Specification

Rejection of Claims 15-57 under 35 U.S.C. § 102(e)

**Marked-up Version of Amended Specification
Pursuant to 37 C.F.R. §§ 1.121(b)**

FIG. 8

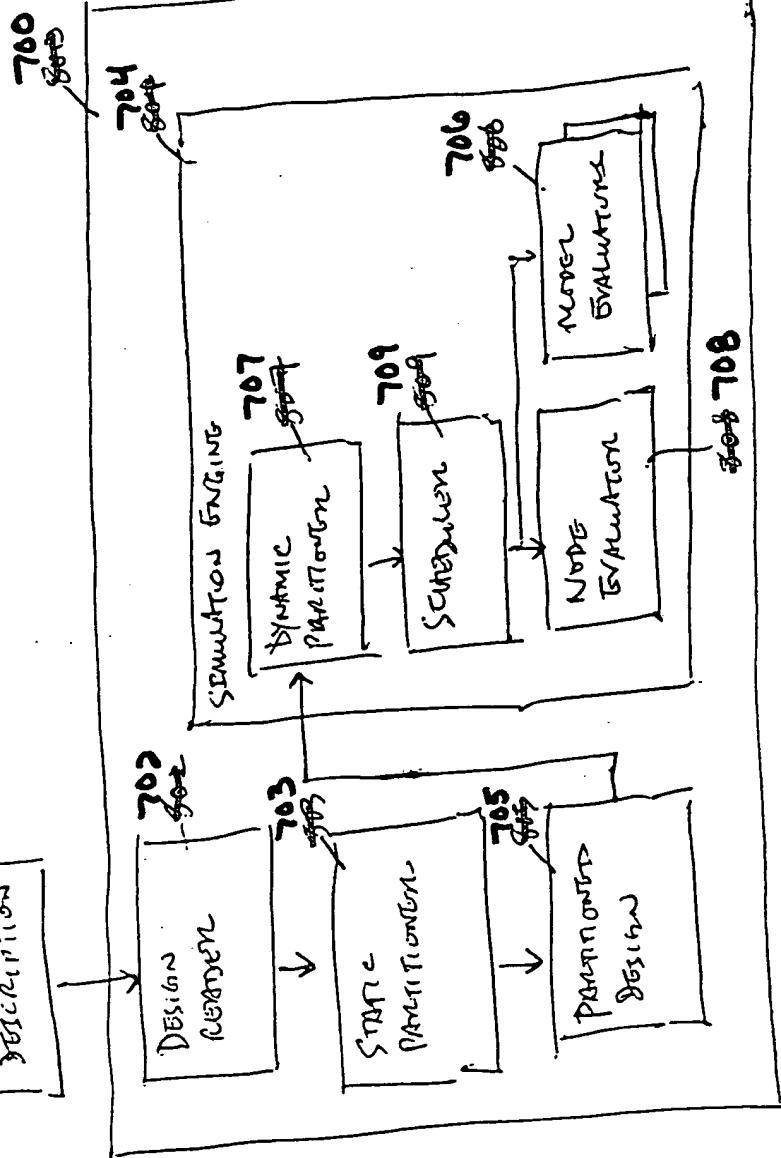
Figure 7 [8] is a block diagram illustrating an overview of an IC design simulation tool.

Figure 7 [8] is a block diagram illustrating an overview of an IC design simulation tool. As illustrated, IC design simulation tool 700 [800] is constituted with design reader 702 [802], static partitioner 703 [803] and simulation engine 704 [804] comprising dynamic partitioner 707 [807], scheduler 709 [809], node evaluator 708 [808] and model evaluators 706 [806]. The elements are operatively coupled to each other as shown. Design reader 702 [802] and some model evaluators 706 [806], in particular a transistor model evaluator and a wire model evaluator, are incorporated with the teachings of the present invention. Certain aspects of static partitioner 703 [803], dynamic partitioner 707 [807] and scheduler 709 [809] are the subject of co-pending U.S. Patent application number 09/333,124, filed June 14, 1999, and entitled "CIRCUIT SIMULATION USING DYNAMIC PARTITION AND ON-DEMAND EVALUATION" which is hereby fully incorporated by reference.

Design reader 702 [802] is used to read design description 710 [810] provided by a designer. Design description 710 [810] includes connectivity information connecting various models modeling electronic devices in the IC design. In one embodiment, in addition to flattening a hierarchical design, design reader 702 [802], also assigns device characterizations to selected ones of the electronic devices of the IC design. In one embodiment the device characterizations are determined as described above. Static partitioner 703 [803] pre-compiles or pre-partitions the IC design into static partitions as well as pre-processes the static partitions into a form particularly suitable for the dynamic partitioner 707 [807].

During simulation, dynamic partitioner 707 [807] further forms and re-forms dynamic partitions of the IC design that are relevant, referencing the pre-formed static partitions. Scheduler 709 [809] determines whether evaluations are necessary for the dynamic partitions for the particular simulation time step, and schedules the dynamic partitions for evaluation on an as-needed or on-demand basis. Accordingly, node evaluator 708 [808] and model evaluators 706 [806] are selectively invoked on an as-needed or on-demand basis to evaluate the states of the connections connecting the models, and various parameter values of the models, such as current, voltage and so forth, respectively.

Fig. 8

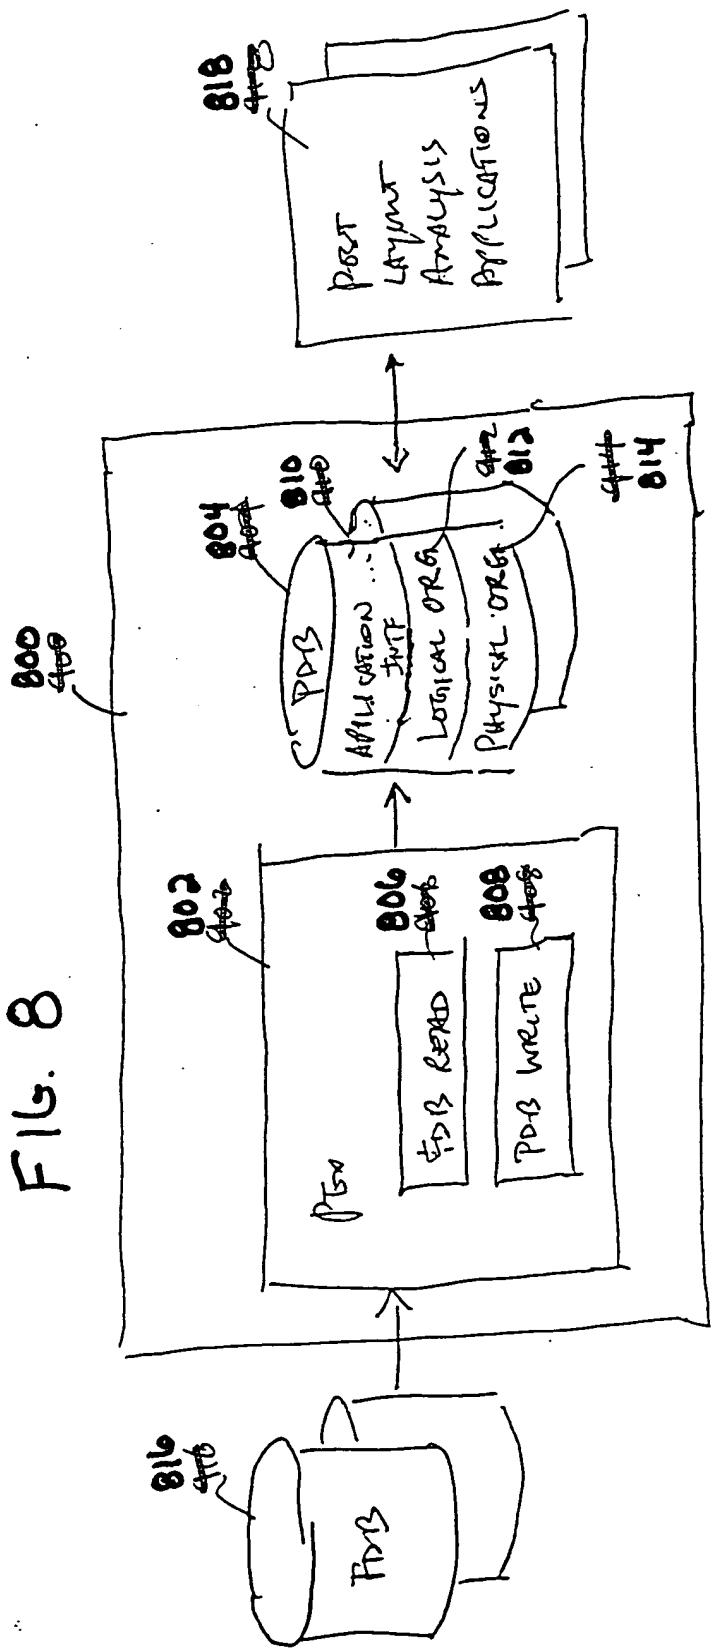
Figure 8 [9] is a block diagram illustrating one embodiment of a parasitic extraction tool suitable for use with the present invention.

Figure 8 [9] is a block diagram illustrating one embodiment of a parasitic extraction tool suitable for use with the present invention. As illustrated, the present invention includes parasitic extraction tool (PEX) 802 [902] and parasitic database (PDB) 804 [904]. PEX 802 [902] generates electrical modeling data for layout nets of an IC design, e.g. a deep sub-micron IC design, and stores the generated electrical modeling data in PDB 804 [904] for use by client applications, such as post layout analysis applications 818 [918]. Examples of post-layout analysis applications 818 [918] include Delay Calculator by Ultima Technology of Sunnyvale, CA, and Path Mill and Time Mill by Synopsis Inc. of Mountain View, CA.

PEX 802 [902] generates the electrical modeling data for the layout nets using extracted connectivity and geometrical data of the layout nets. In one embodiment PEX 802 [902] generates capacitive modeling data as described above. As shown, PEX 802 [902] includes read function 806 [906] that operates to input these connectivity and geometrical data of the layout nets. For the illustrated embodiment, the extracted connectivity and geometrical data of the layout nets are input from filtered databases (FDB) 816 [916].

The extracted connectivity and geometrical data are stored in FDB 816 [916] by layout cell hierarchies, one FDB per layout cell hierarchy, and indexed by layout nets. The connectivity and geometrical data were extracted at least in part in accordance with specified parasitic effect windows of the various layers of the IC design. Read function 806 [906] operates to retrieve the connectivity and geometrical data of the layout nets from FDB 816 [916] using the stored layout net indices. FDB 816 [916] is the subject of co-pending U.S. Patent application number 09/052,895, filed March 31, 1998, and entitled "METHOD AND APPARATUS FOR EXTRACTING AND STORING CONNECTIVITY AND GEOMETRICAL DATA FOR A DEEP SUB-MICRON INTEGRATED CIRCUIT DESIGN," which is assigned to the corporate assignee of the present invention. The co-pending application is hereby fully incorporated by reference.

PDB 804 [904] is designed to accommodate a large volume of electrical modeling data and concurrent accesses by multiple client applications, which is typically of today's and future deep sub-micron IC designs and design environments. For the illustrated embodiment, PDB 804 [904] has physical organization 814 [914] that allows a large volume of electrical modeling data to be stored in multiple physical media, and application interface 810 [910] that shields physical organization 814 [914] from PDB users, e.g. PEX 802 [902] and post layout analysis applications 818 [918]. Additionally, PDB 802 [902] has logical organization 812 [912] that abstracts physical organization 814 [914] to facilitate implementation of application interface 810 [910].

For the illustrated embodiment, PEX 802 [902] includes write function 808 [908] that operates to store the generated electrical modeling data of the layout nets into PDB 804 [904] using application interface 810 [910]. In alternate embodiments, write function 808 [908] may store the generated electrical modeling data of the layout nets using either logical and/or physical organizations 812-814 [912-914]. Similarly, selected ones of the client applications, e.g. post-layout analysis applications 818 [918], may also elect to access PDB 804 [904] through logical and/or physical organizations 812-814 [912-914].

Read function 806 [906] and write function 808 [908] are the subject of co-pending U.S. Patent application number 09/052,915, filed March 31, 1998 and entitled "METHOD AND APPARATUS FOR GENERATING AND MAINTAINING ELECTRICAL MODELING DATA FOR A DEEP SUB-MICRON INTEGRATED CIRCUIT DESIGN," which is assigned to the corporate assignee of the present invention. The co-pending application is hereby fully incorporated by reference. Except for read function 806 [906] and write function 808 [908], PEX 802 [902] is intended to represent a broad category of electrical modeling tools known in the art. Examples of these electrical modeling tools include but not limited to Pattern Engine of xCalibre by Mentor Graphics, Columbus by Frequency Technology of San Jose, CA, and Arcadia by Synopsis.

Fig. 9

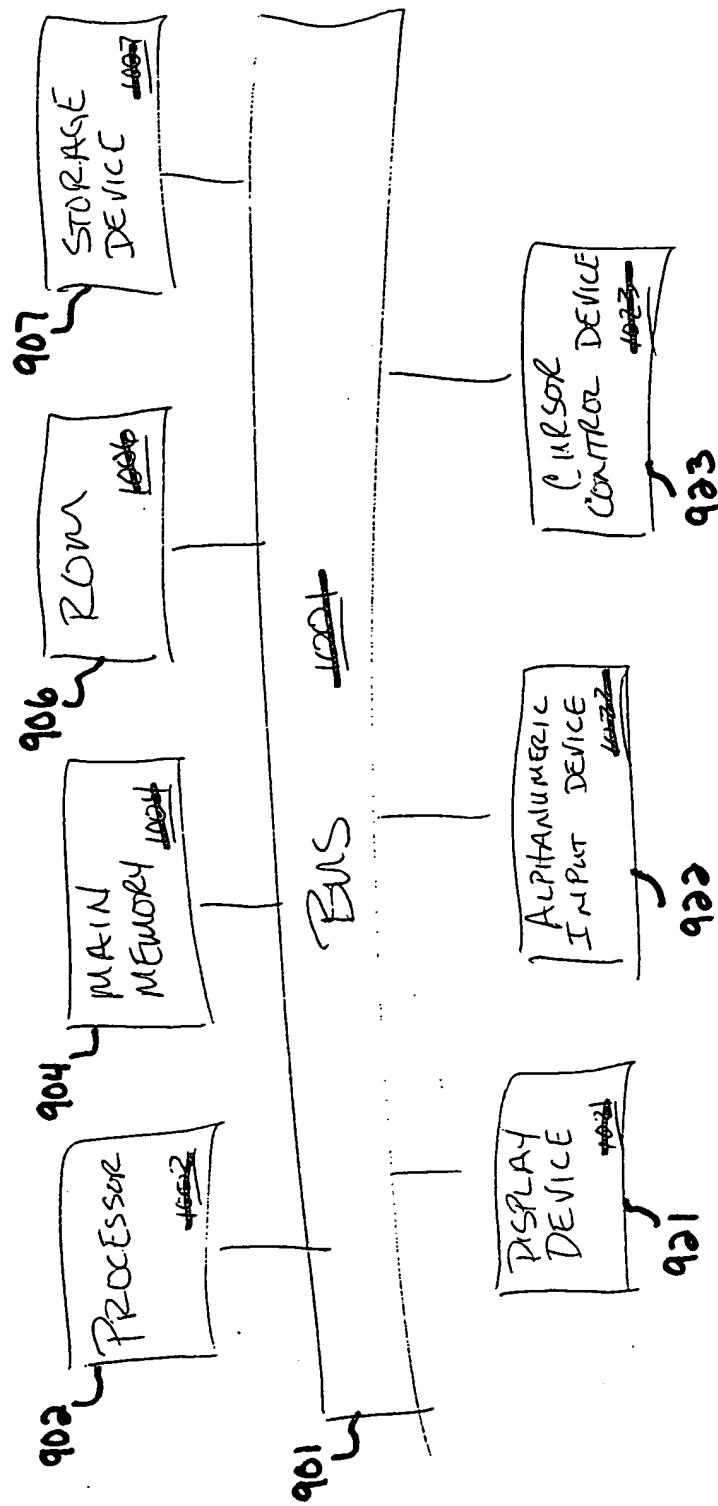
Figure 9 [10] is one embodiment of a computer system suitable for use with the invention.

Figure 9 [10] is one embodiment of a computer system suitable for use with the invention. Computer system 900 [1000] can be used, for example, for extraction and/or modeling of integrated circuits using the teachings of the present invention. Computer system 900 [1000] includes bus 901 [1001] or other communication device to communicate information and processor 902 [1002] coupled to bus 901 [1001] to process information. While computer system 900 [1000] is illustrated with a single processor, computer system 900 [100] can include multiple processors and/or co-processors. Computer system 900 [1000] further includes random access memory (RAM) or other dynamic storage device 904 [1004] (referred to as main memory), coupled to bus 901 [1001] to store information and instructions to be executed by processor 902 [1002]. Main memory

Computer system 900 [1000] also includes read only memory (ROM) and/or other static storage device 906 [1006] coupled to bus 901 [1001] to store static information and instructions for processor 902 [1002]. Data storage device 907 [1007] is coupled to bus 901 [1001] to store information and instructions. Data storage device 907 [1007] such as a magnetic disk or optical disc and corresponding drive can be coupled to computer system 900 [1000].

Computer system 900 [100] can also be coupled via bus 901 [1001] to display device 921 [1021], such as a cathode ray tube (CRT) or liquid crystal display (LCD), to display information to a computer user. Alphanumeric input device 922 [1022], including alphanumeric and other keys, is typically coupled to bus 901 [1001] to communicate information and command selections to processor 902 [1002]. Another type of user input device is cursor control 923 [1023], such as a mouse, a trackball, or cursor direction keys to communicate direction information and command selections to processor 902 [1002] and to control cursor movement on display 921 [1021].

According to one embodiment, extraction and/or modeling can be performed by computer system 900 [1000] in response to processor 902 [1002] executing sequences of instructions contained in main memory 904 [1004]. Instructions are provided to main memory 904 [1004] from a storage device, such as magnetic disk, a read-only memory (ROM) integrated circuit (IC), CD-ROM, DVD, via a remote connection (e.g., over a network), etc. In alternative embodiments, hard-wired circuitry can be used in place of or in combination with software instructions to implement the present invention. Thus, the present invention is not limited to any specific combination of hardware circuitry and software instructions.
